Wirelock CTW Improvement Proposal_10153126

2024/09/14

Wirelock CTW Assembly Analysis

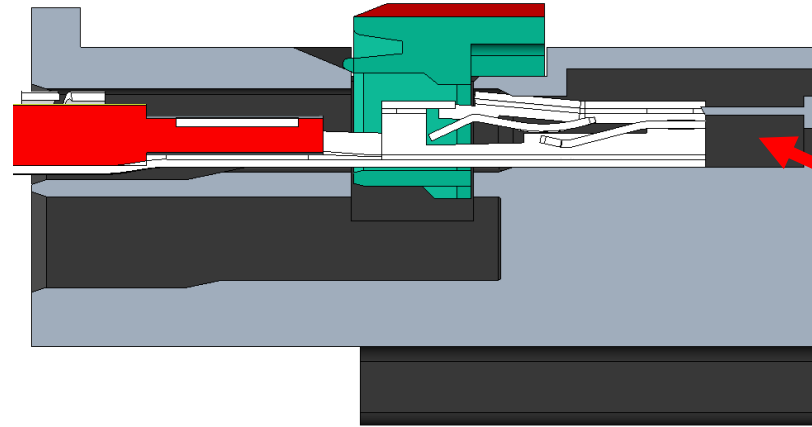
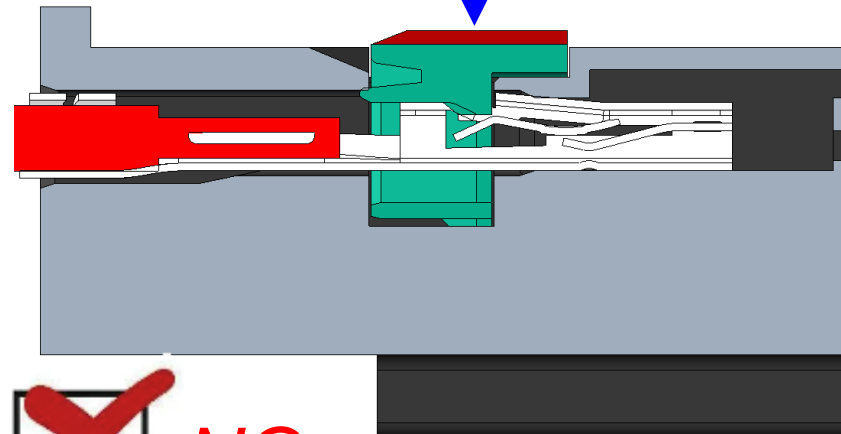
The terminal is not fully inserted into the slot.

The TPA will touch the secondary locking position when terminal isn't correctly inserted.

Change Details

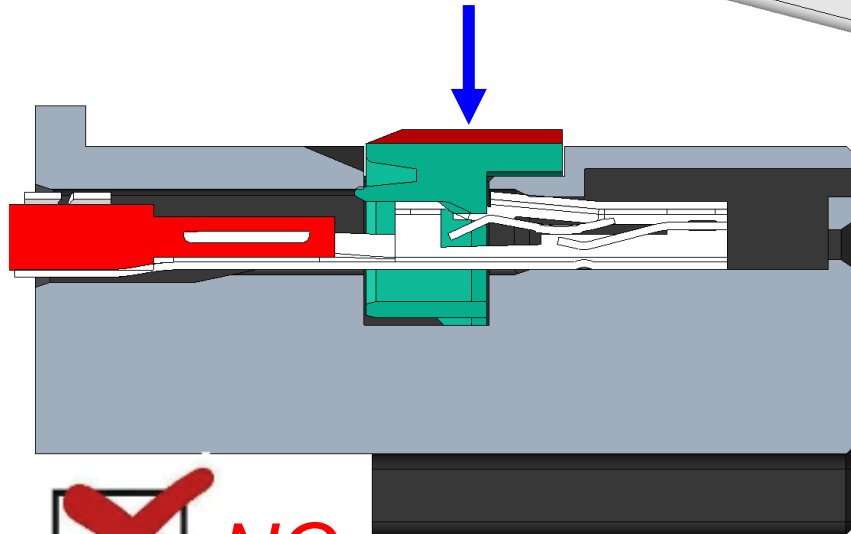
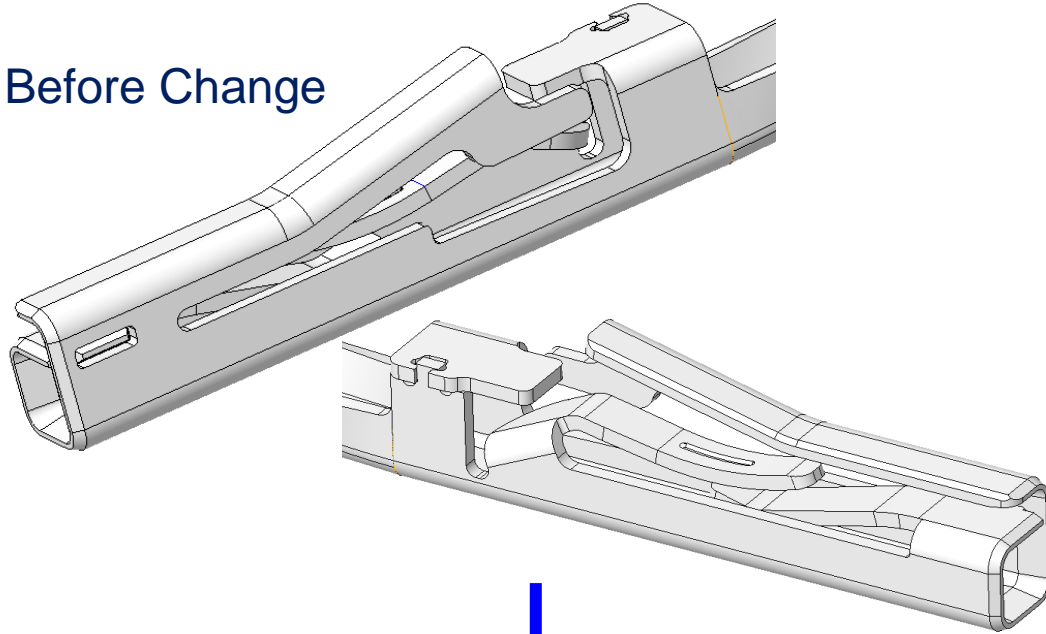
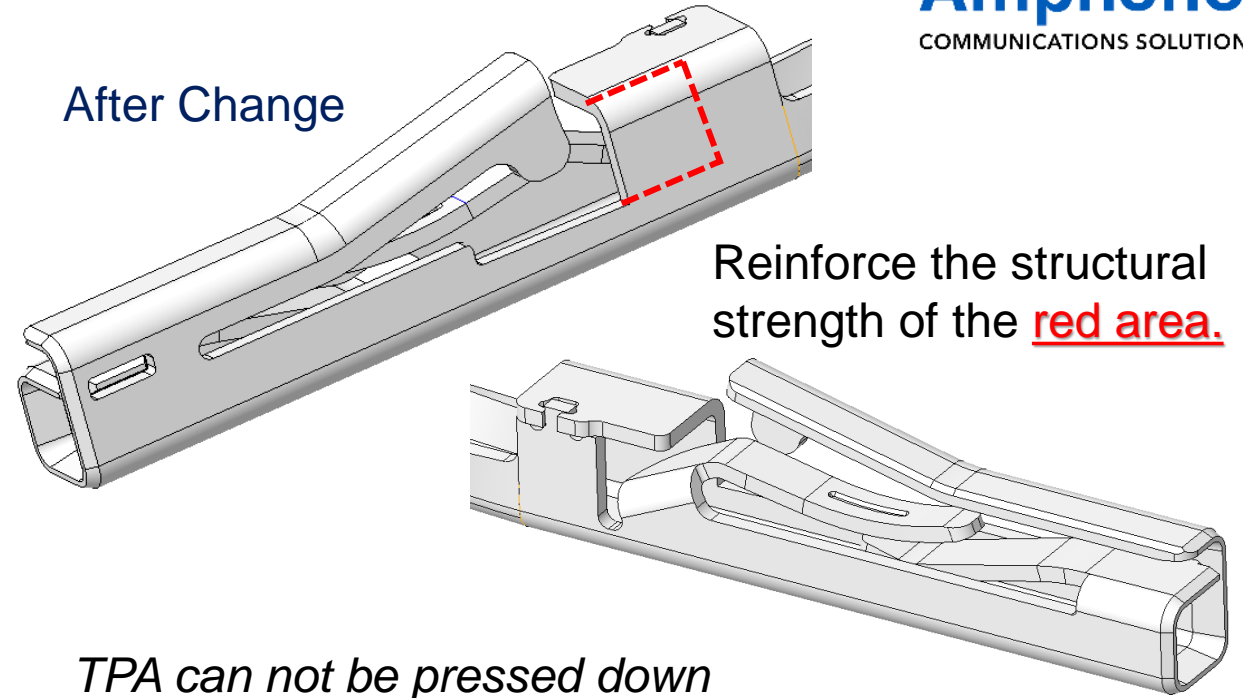
Before Change

After Change

Reinforce the structural strength of the red area.

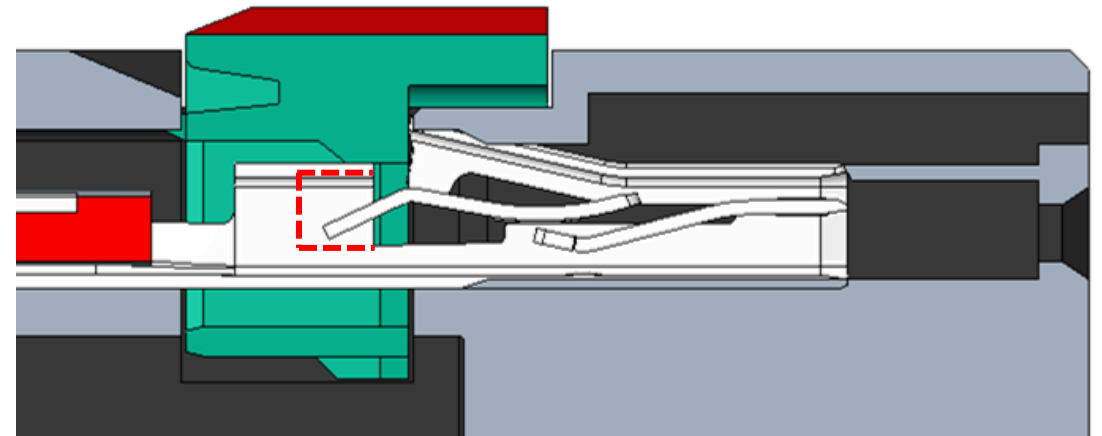
TPA can not be pressed down

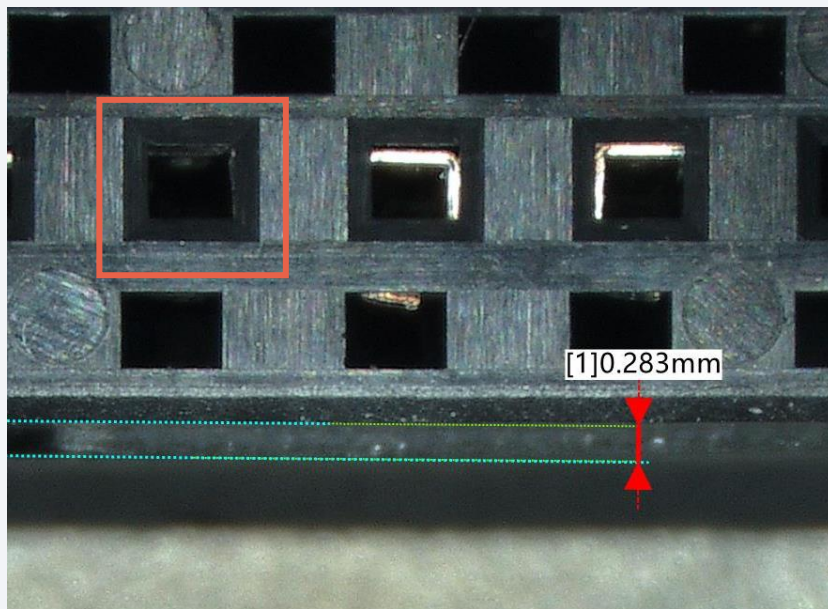
The terminals in the orange box are not properly installed

Sample 1:
TPA protrudes housing 0.283mm

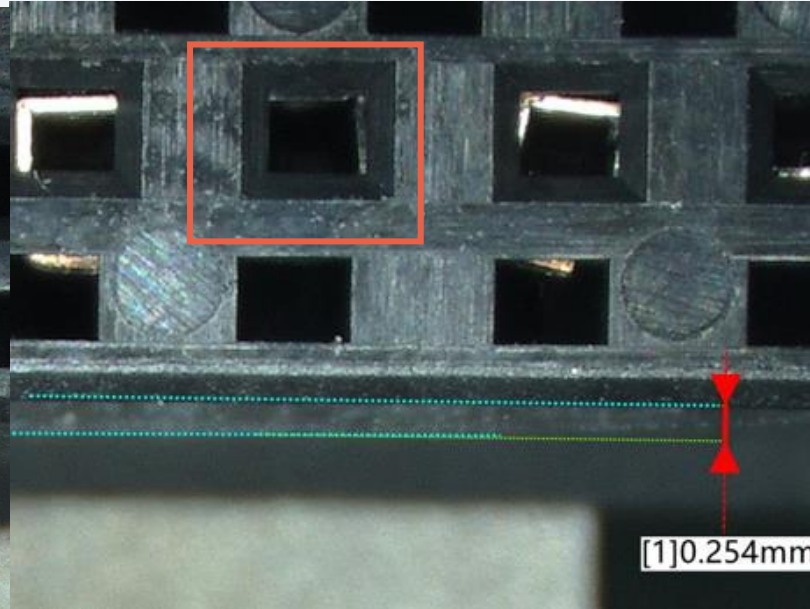
Sample 2:
TPA protrudes housing 0.254mm

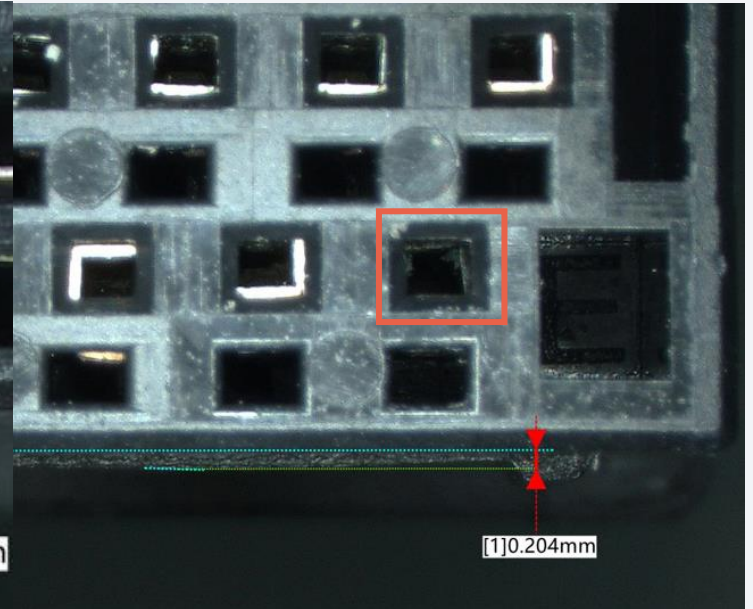
Sample 3:
TPA protrudes housing 0.204mm

F2: Forward Stop Force 35N Min

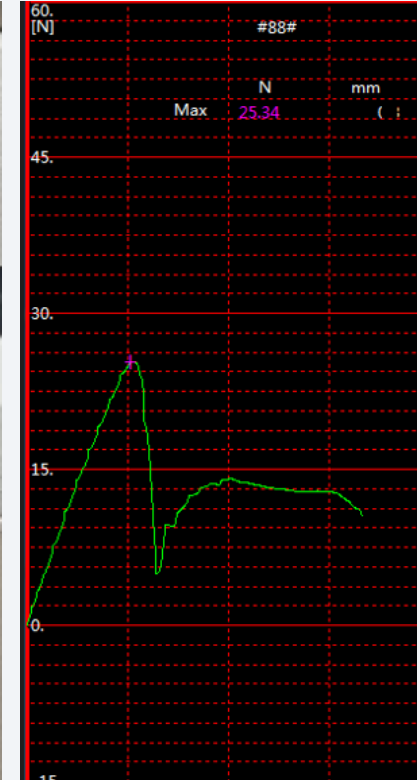
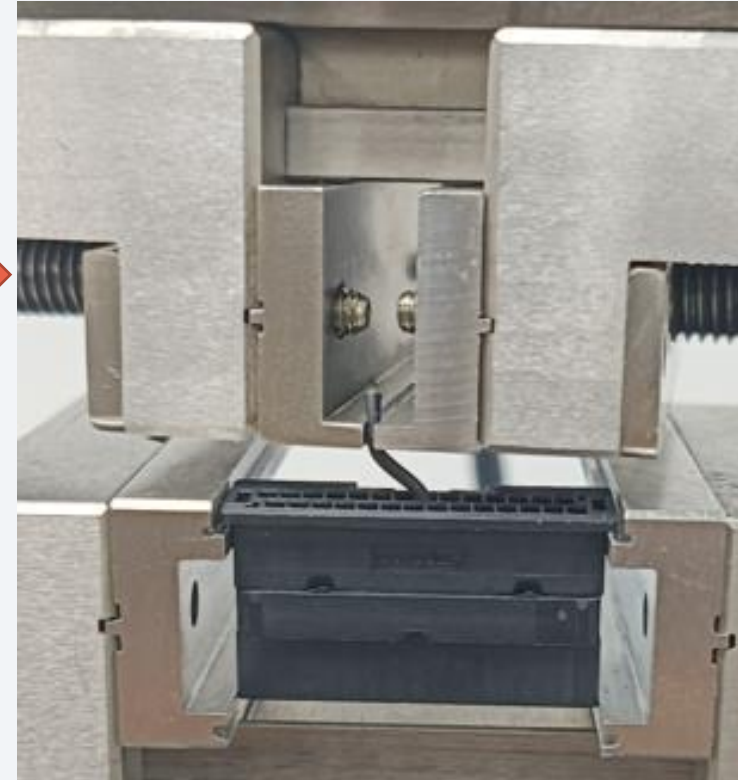
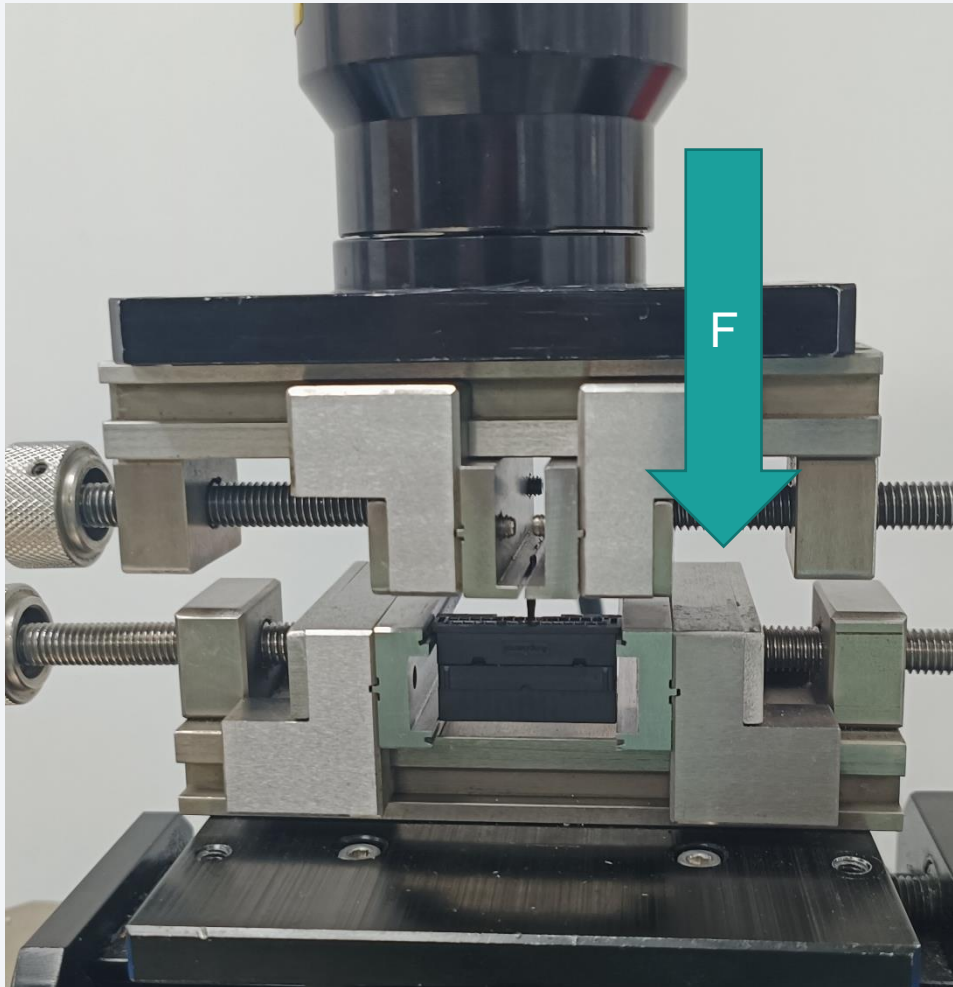
When the force reaches 25N, the line's bearing capacity reaches the upper limit and collapses first

F2: Forward Stop Force 35N Min

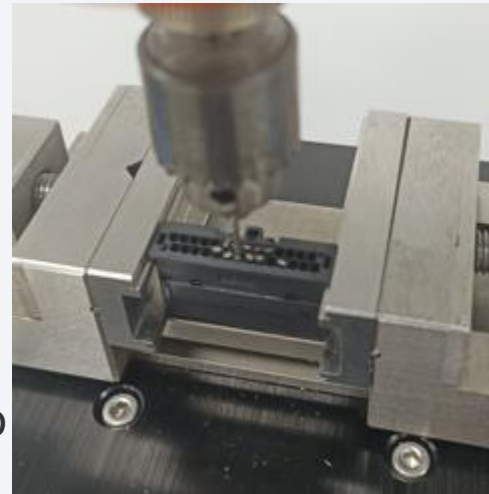
Use a steel needle instead of a thread to press down
